UNITED STATES PATENT AND TRADEMARK OFFICE

APPLICATION NO.	FILING DATE	FIRST NAMED INVENTOR	ATTORNEY DOCKET NO.	CONFIRMATION NO.
10/664,195	09/17/2003	Todd M. Bjork	M81.12-0068	3894
27367	7590	02/26/2007	EXAMINER	
WESTMAN CHAMPLIN & KELLY, P.A. SUITE 1400 900 SECOND AVENUE SOUTH MINNEAPOLIS, MN 55402-3319			RAMANA, ANURADHA	
		ART UNIT	PAPER NUMBER	
		3733

Office Action Summary	Application No.	Applicant(s)	
	10/664,195	BJORK ET AL.	
	Examiner	Art Unit	
	Anu Ramana	3733

DETAILED ACTION***Double Patenting***

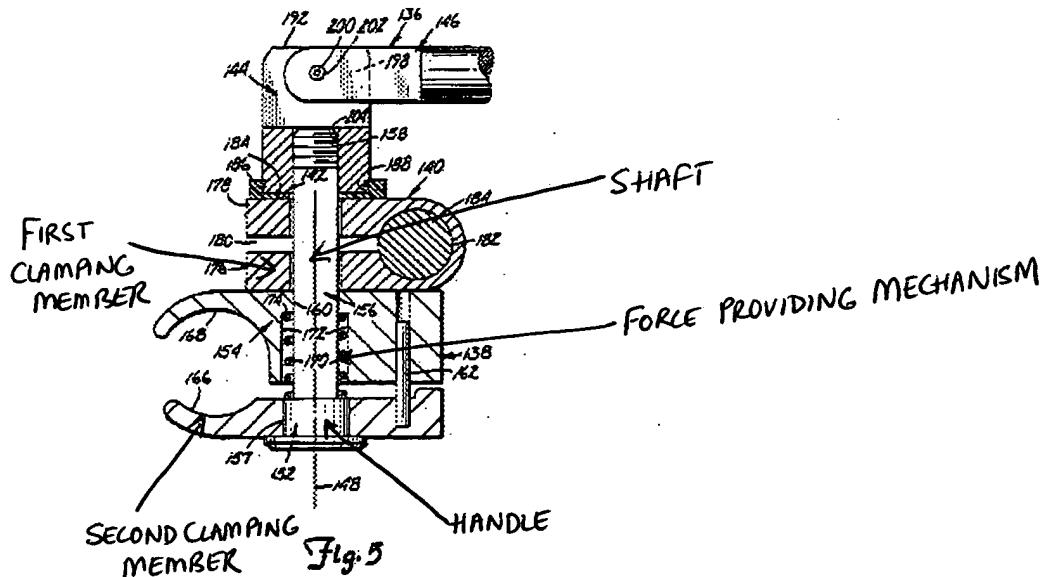
Claims 1, 2 and 8 are rejected under 35 U.S.C. 102(b) as being anticipated by LeVahn et al. (US 4,949,707).

LeVahn et al. disclose a surgical joint including a first clamping member, a second clamping member a shaft 156 positioned within the attachment end of the first clamping member and in communication with the second clamping member and a spring or "force providing mechanism" 170 disposed about the shaft wherein a handle is attached to the force providing mechanism (Fig. 5, col. 6, lines 48-68 and col. 7, lines 1-19). See marked up Fig. 5 below.

Applicants' arguments with respect to the rejections of claim 1, 2 and 8 as being anticipated by LeVahn et al. are not persuasive. It is noted that a handle is, "any part designed to be held with a hand (Source: The American Heritage® Dictionary of the English Language: Fourth Edition. 2000)." Clearly, 152 is capable of being held by a hand, at least during assembly of the LeVahn et al. device. It is noted that Applicants are not claiming the function of their handle in claim 1 in order to patentably distinguish over LeVahn et al.

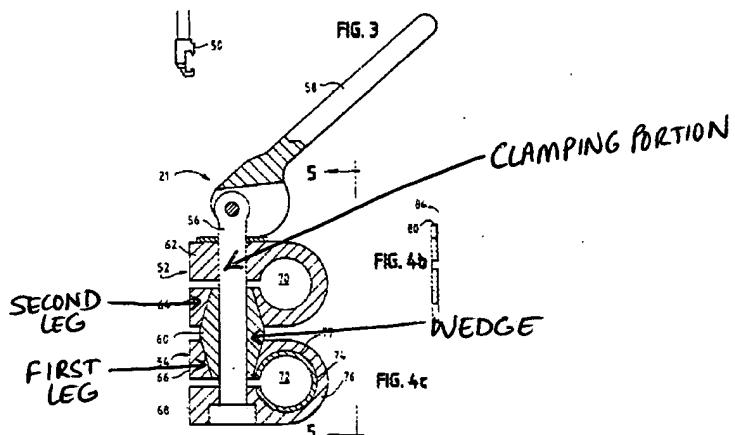
Claims 15-16 and 19 are rejected under 35 U.S.C. 102(b) as being anticipated by Farley et al. (US 6,033,363).

Farley et al. disclose a surgical clamp including a clamping portion 56, a first leg 54 and a second leg 64 and a wedge 60 disposed between the first and second legs wherein the wedge is movable to force the legs in opposite directions (Fig. 3 and col. 3, lines 29-40). See marked up Fig. 3 below.

"Unitary construction" only implies that the first leg and the second leg are units or "mechanical parts." It is suggested that Applicants recite that the clamping portion includes or comprises a first leg and a second leg to tie the first leg and the second leg to the same clamping portion.
